Cobra Motorcycle Mfg.

TSB1408 CX50 JR / OI radiator

May 1, 2008

Figure A

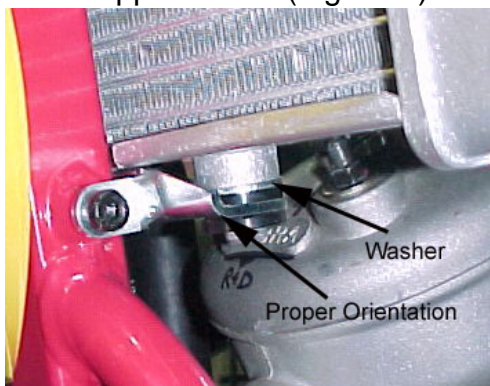
1. The bottom radiator mount must now be mounted upside down from the previous mounting arrangement. Proper bracket orientation is shown in Figure A and there is a washer between the grommet and the radiator.
2. A spacer is supplied to aid in mounting the radiator in a true horizontal position. The spacer goes between the bracket and the frame on the upper mount (Figure B).
